Revisions and Errata List AISC Steel Design Guide 22, 1st printing (Printed Copy) March 20, 2014

The following list represents corrections to the first printing of AISC Design Guide 22, Façade Attachments to Steel-Framed Buildings.

Fig. 7-28. Hanger assembly moment diagram with pin at spandrel beam web.

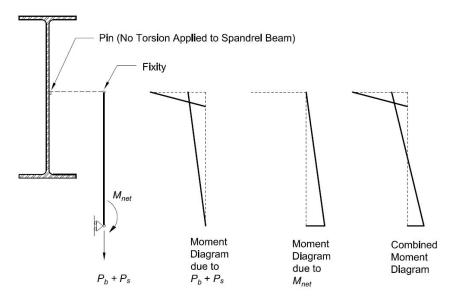
Replace Figure 7-28 with the following—the pin should be shown at the beam web and the fixity should be shown between the outrigger and the hanger.
